# Access Compliance Report

## Public Rights-of-Way

### (Curb Ramps)

Intersection ID: 14648	Main Street: EAST_BV	Cross Street: LENNOX_AV	Location: E
ADA ID: CA2B8EBFA783	Ramp Type: Directional1	Initial Pass/Fail: Pass	Overall Compliance: No
Severity Score: 15.25			
Codes/Mitigation Info/Possible Solution		Field Measurements/Component Compliance

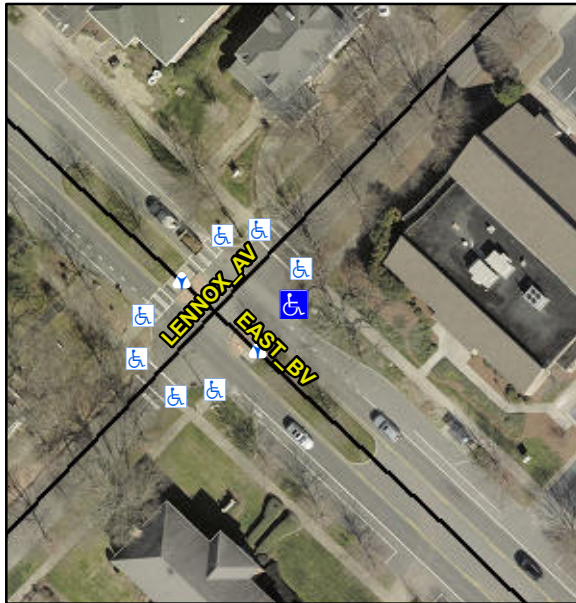
**LNDG SLOPE NEGATIVE, GTR GAP  
18.0"**

**R304.5.3, R304.2.2-Perp, R304.3.2-  
Para, R302.7.2**

**Remove & Replace Entire Ramp.  
Grind Gutter Lip.**
